Opal St Clair

Response to letter 19th November 2021

17th June 2022

ITEM 2 – Concerned raised

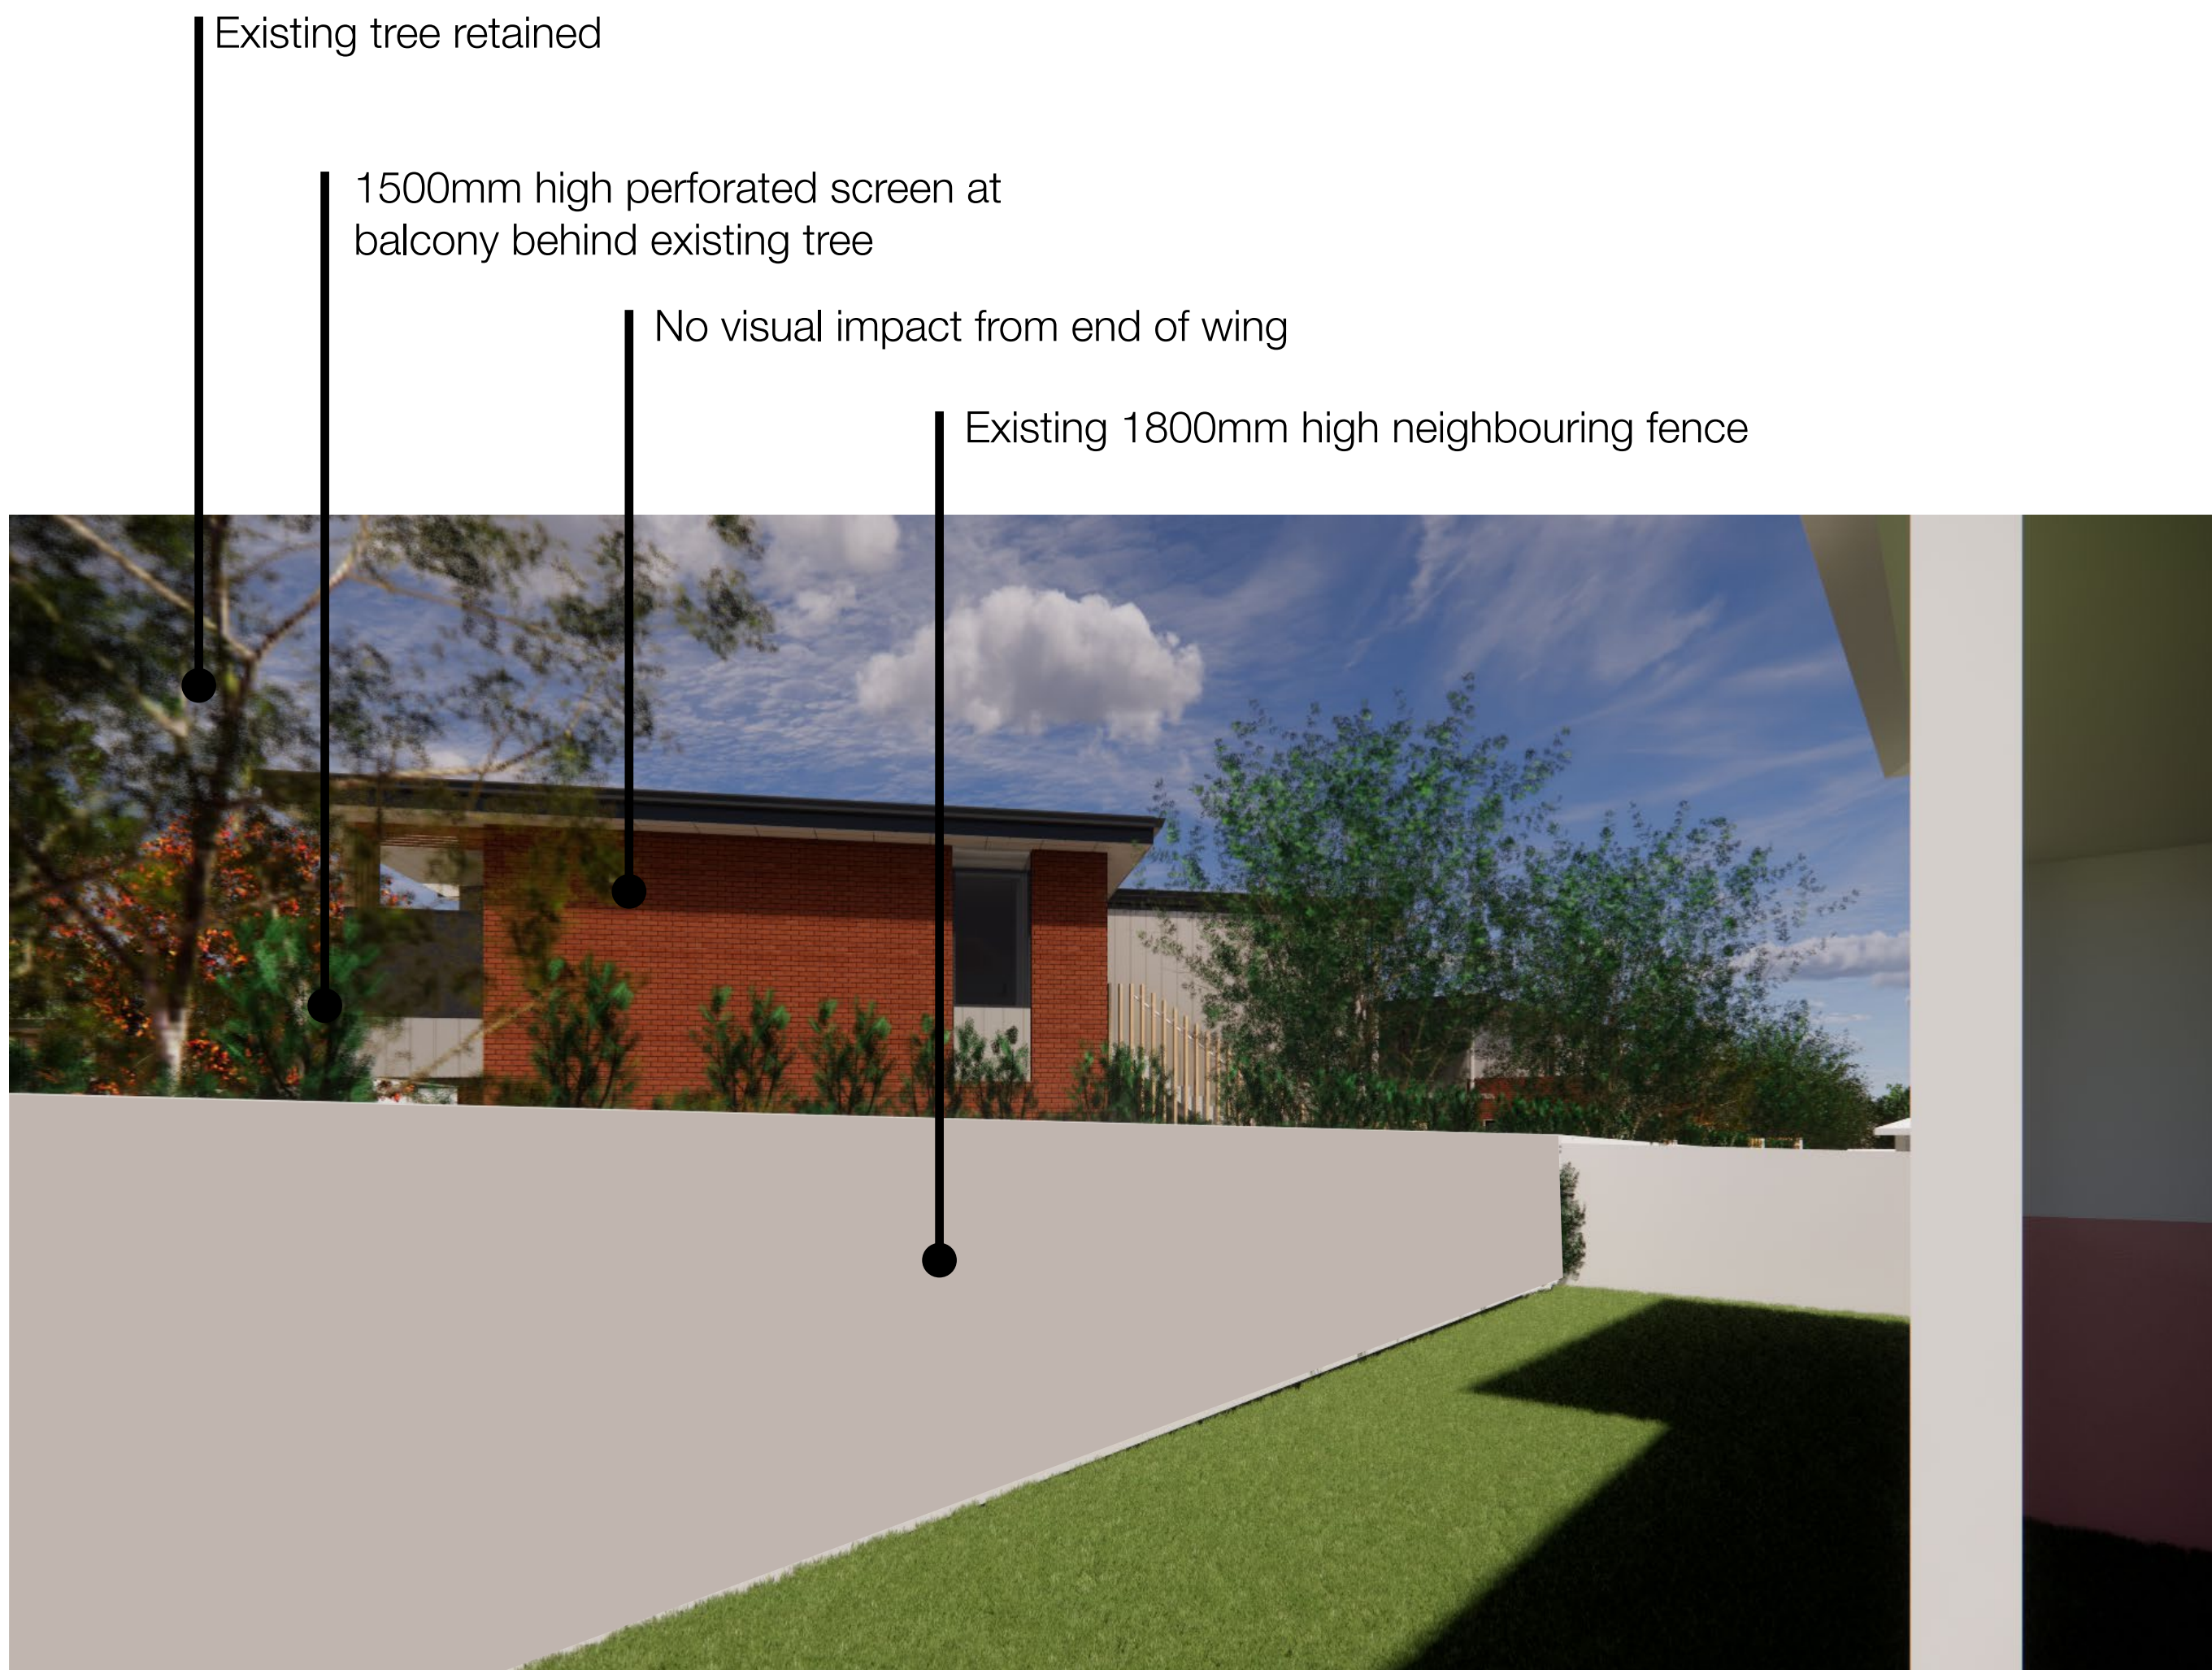
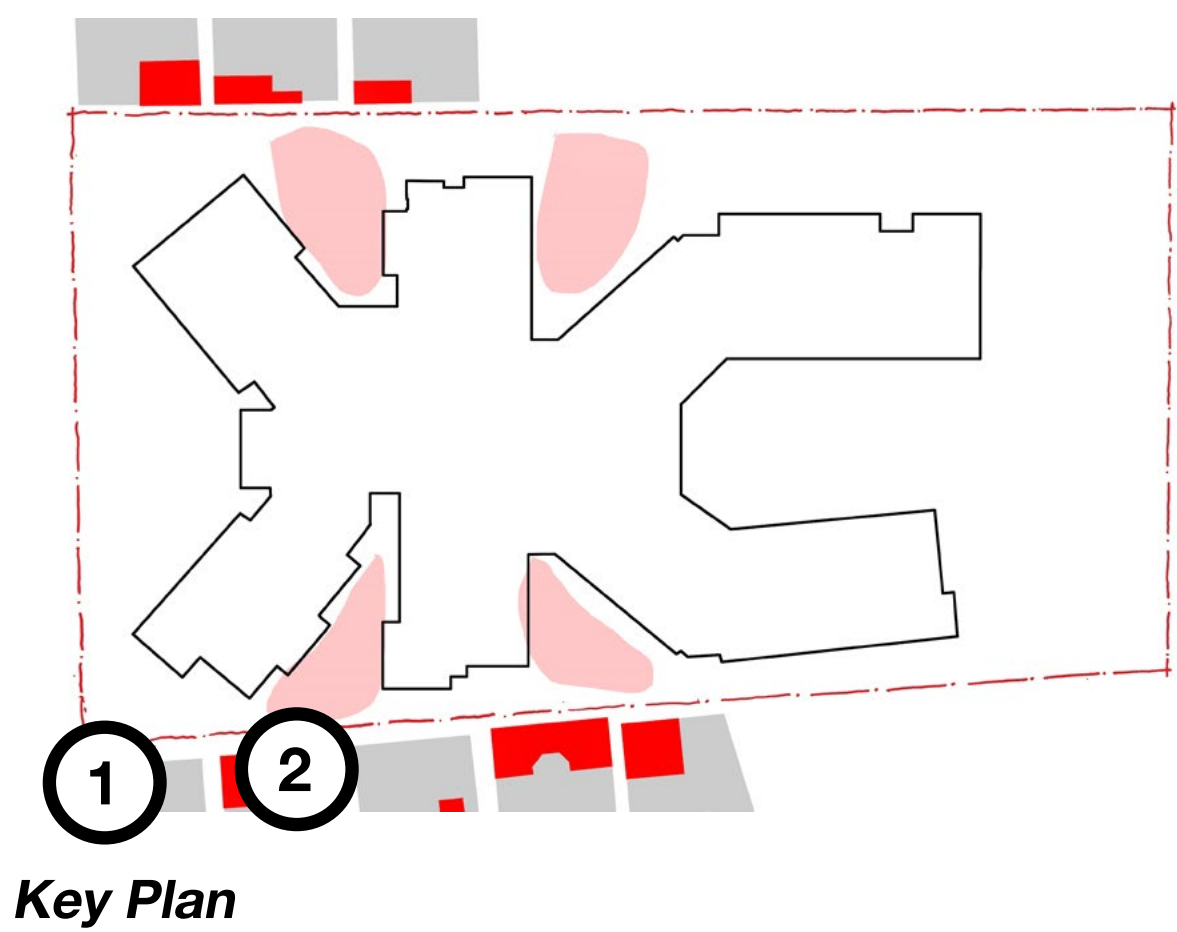
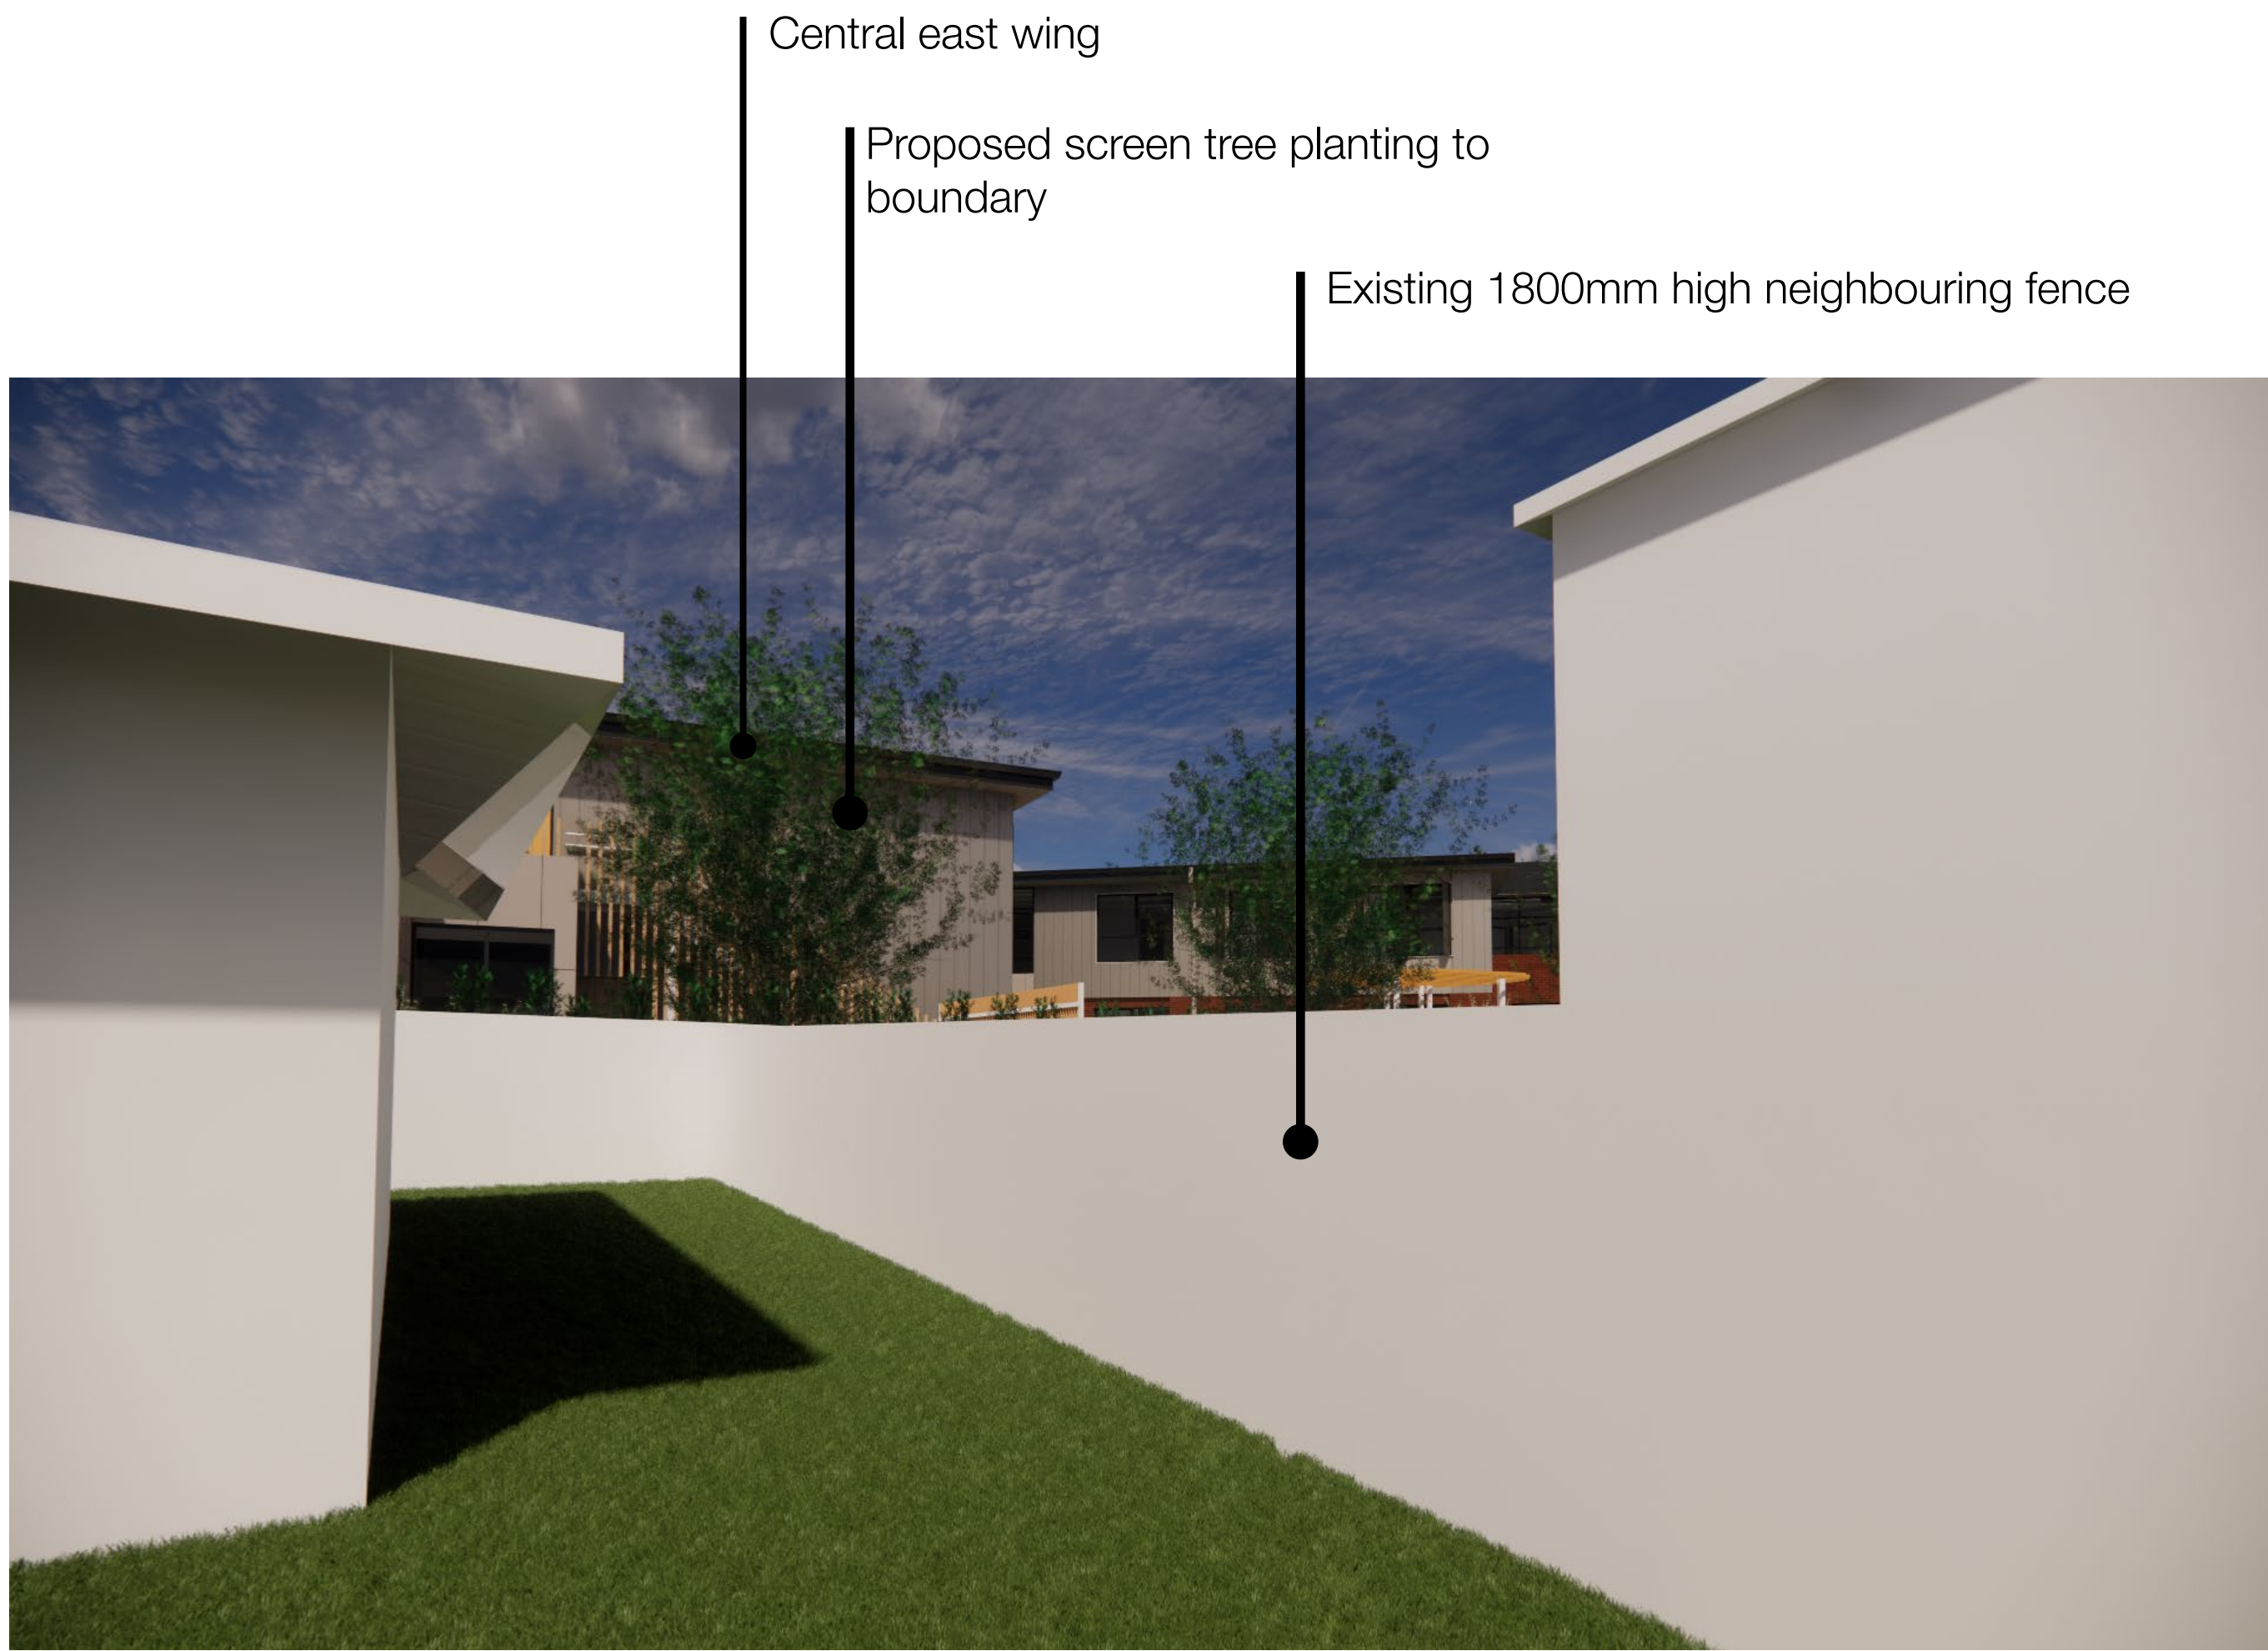
Concern is raised regarding the overall bulk of the building, including the extension of the front and central building wings to within close proximity of the side boundaries, the extension of the north eastern wing to within close proximity of the eastern side boundary, and the provision of ground floor levels which are significantly above the existing ground levels (i.e. up to approximately 2.5m above in the north eastern corner of the development). It is noted that Council's Urban Design Review Panel have reviewed the proposal and have raised issue in relation to the insufficient vertical expression, apparent building length and overall building bulk

The proposed facade treatment adjoining neighbouring dwellings is highly articulated with residential scale particularly in relation to the southern and central wings. A number of views from neighbouring properties have been prepared to illustrate this when viewed from the POS of adjoining properties (shown in red).

Further to the above, modifications are proposed to the building mass through the removal of first floor bedrooms amongst other internal changes. These improvements are reflected in the updated views and the proposed plans reflected on pages on 10 and 11
